2.3 Radiation Monitoring Systems

The information in this section of the ABWR DCD, including all subsections, tables, and figures, is incorporated by reference with the following departures.

STD DEP T1 2.3-1 (Figure 2.3.1)

STD DEP T1 2.14-1 (Table 2.3.3)

Figure 2.3.1 Process Radiation Monitoring System Control Interface Diagram

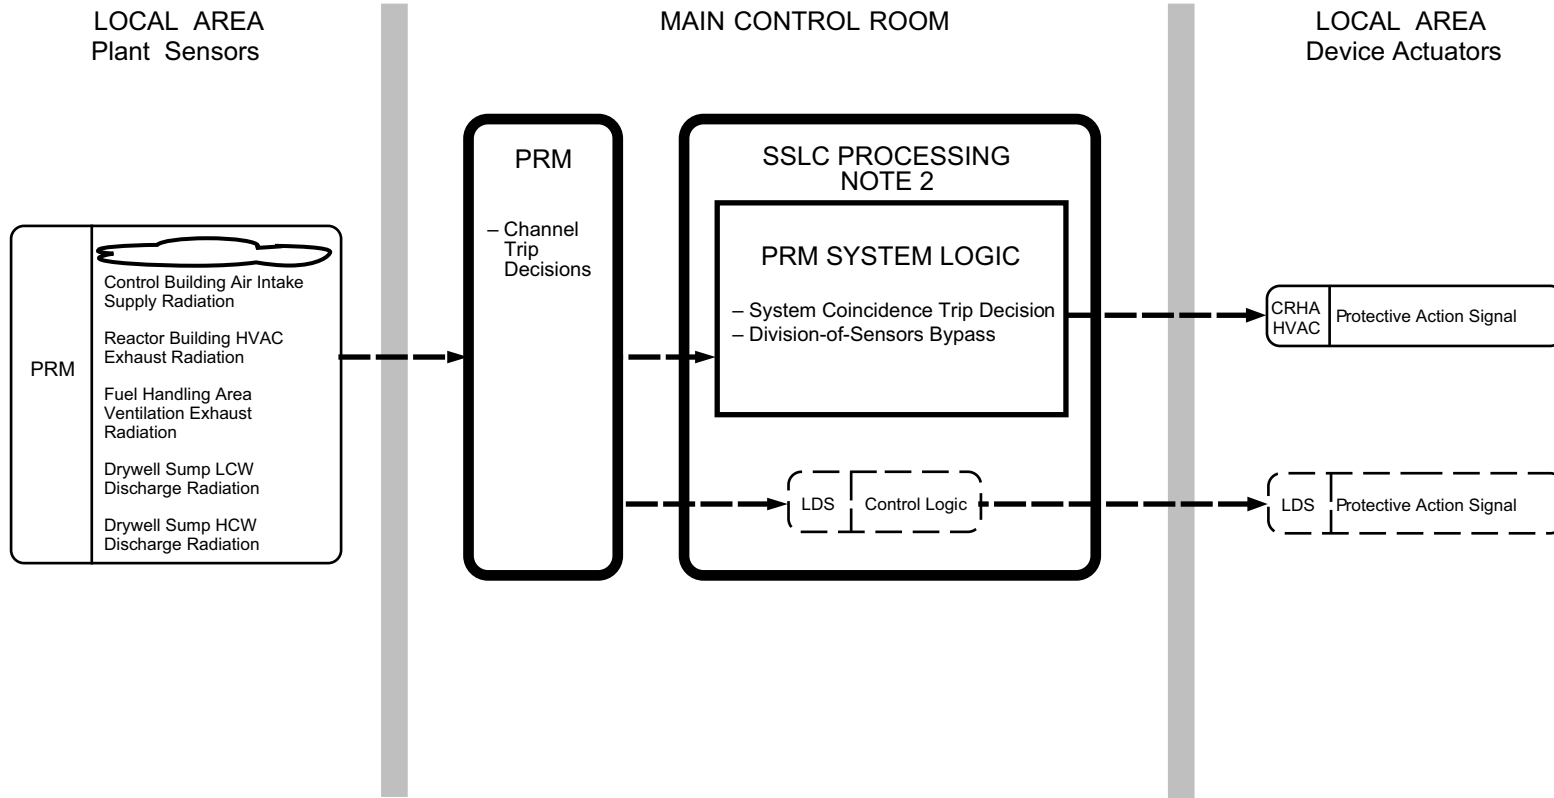
STD DEP T1 2.3-1
